AGENDA

In response to the State's declaration of a Public Health Emergency, the Mayor's Proclamation of Emergency, and the ban on public gatherings of more than five (5) people, the Historic Districts Review Board meeting will be conducted virtually using Zoom.

1. Case #2020-002692-HDRB. 202 Galisteo Street. Downtown & Eastside Historic District. Ryan Allen, agent for Rem Yildirim, owner, proposes to install awnings at ground-level windows and doors on a contributing non-residential structure. An exception is requested to section 14-5.2(D)(2)(c). (Angela Schackel Bordegaray)

PROPOSED EAST ELEVATION

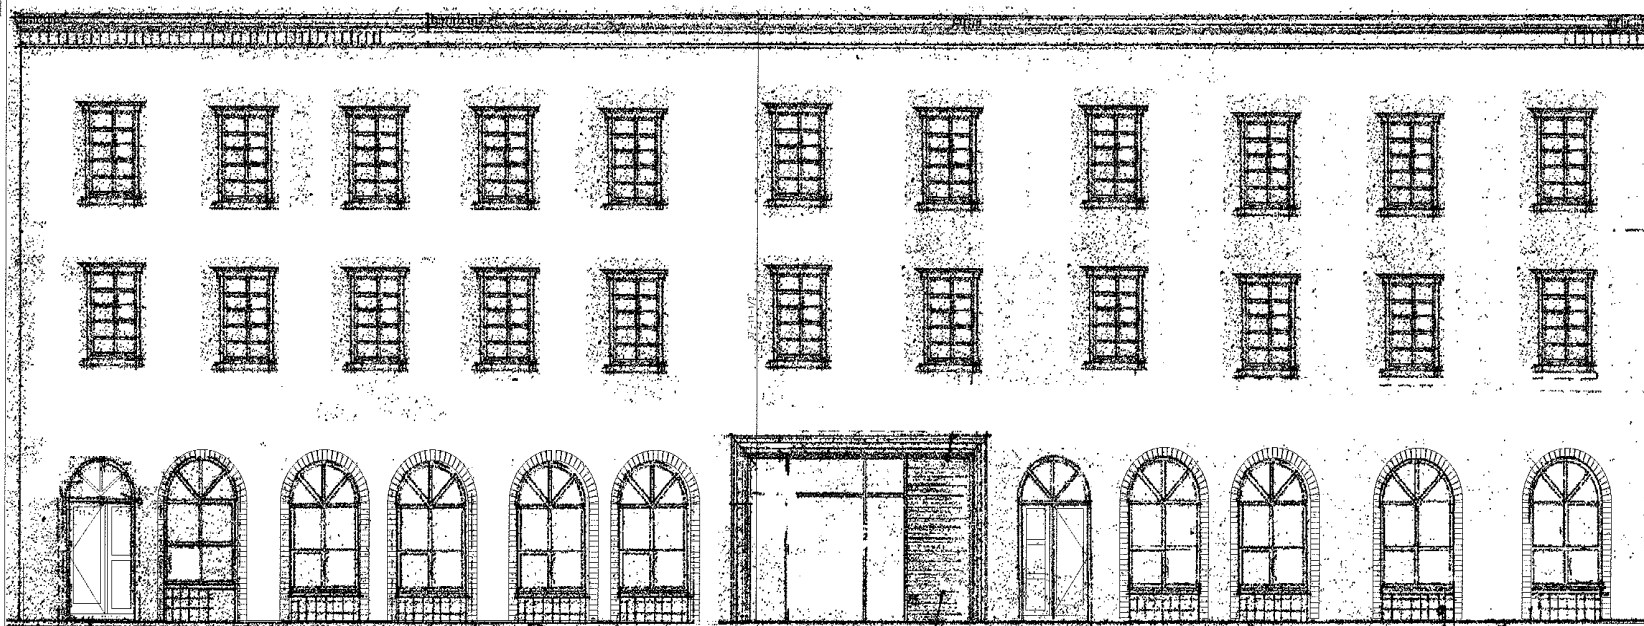
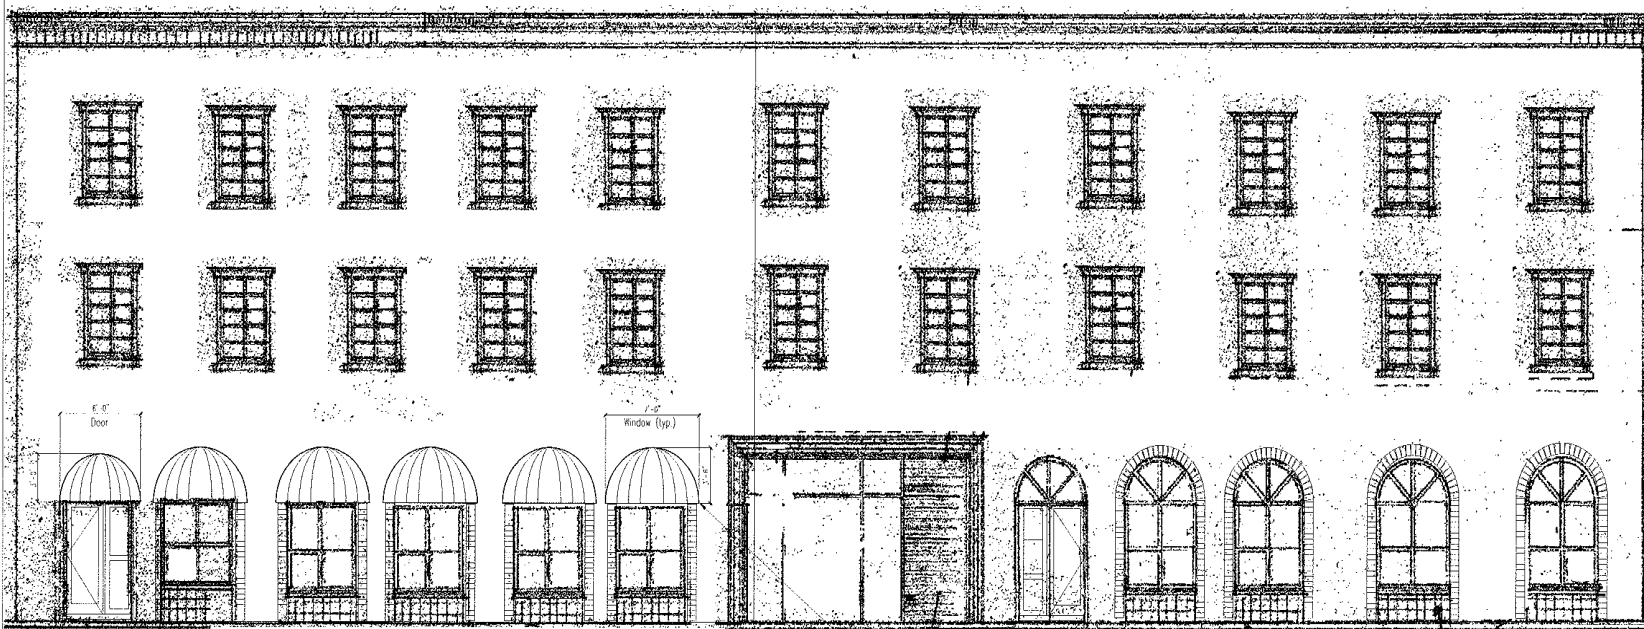
AWNINGS PROPOSED OVER
EXISTING ARCHED WINDOW
AND DOOR OPENINGS (SEE ELEVATIONS M.1)
